Appln No. 09/643,921

Reply to Office action of May 21, 2004

Amendments to the Drawings:

FIG. 14A

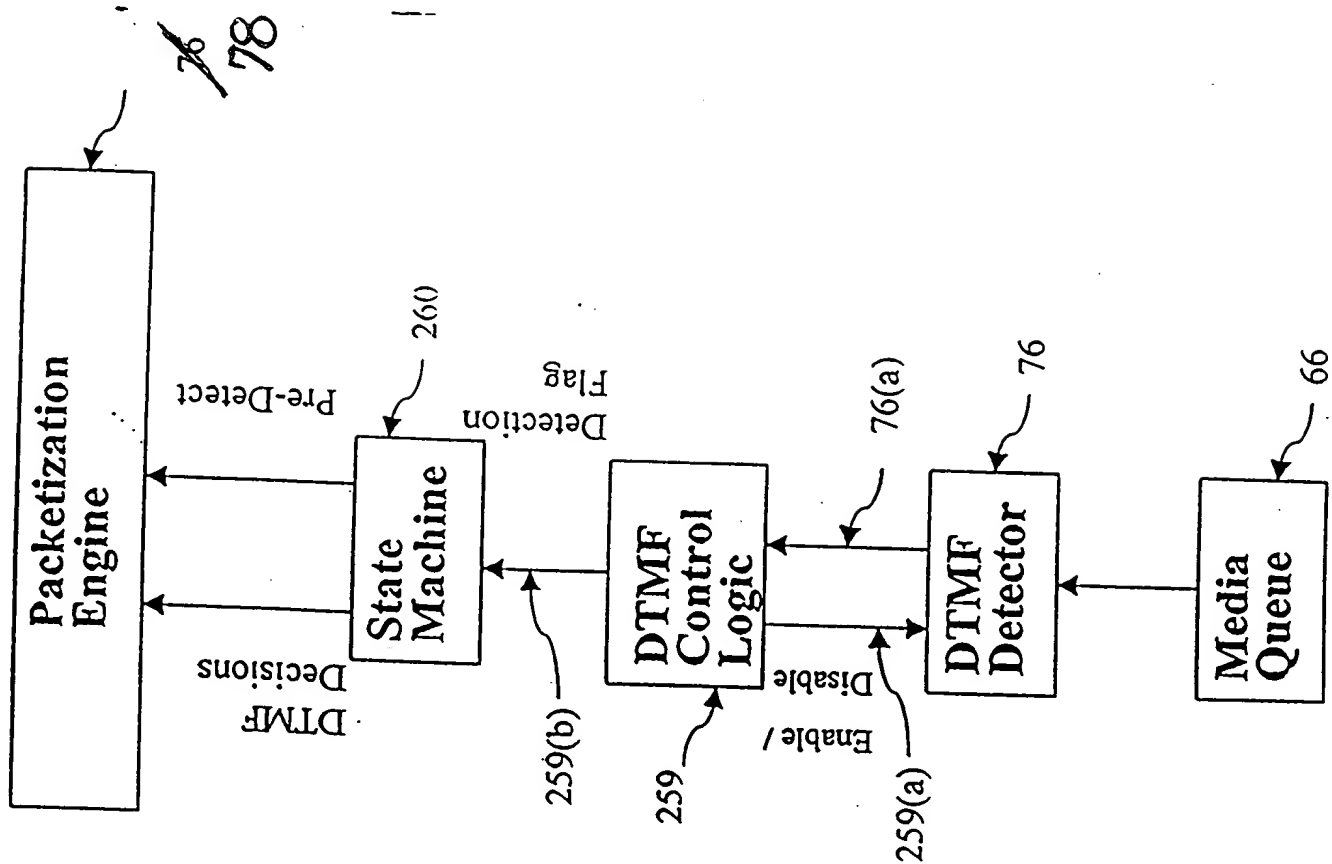
Attached are 35 sheets of drawings for this application. They are submitted as formal drawings to replace the corresponding informal drawings as originally filed. Applicant has amended FIG. 14A to amend the packetization engine reference number from 76 to 78 to conform with the specification as well as FIG. 6. Specific support for the amendment can be found on page 15, line 31. Therefore no new matter has been added.
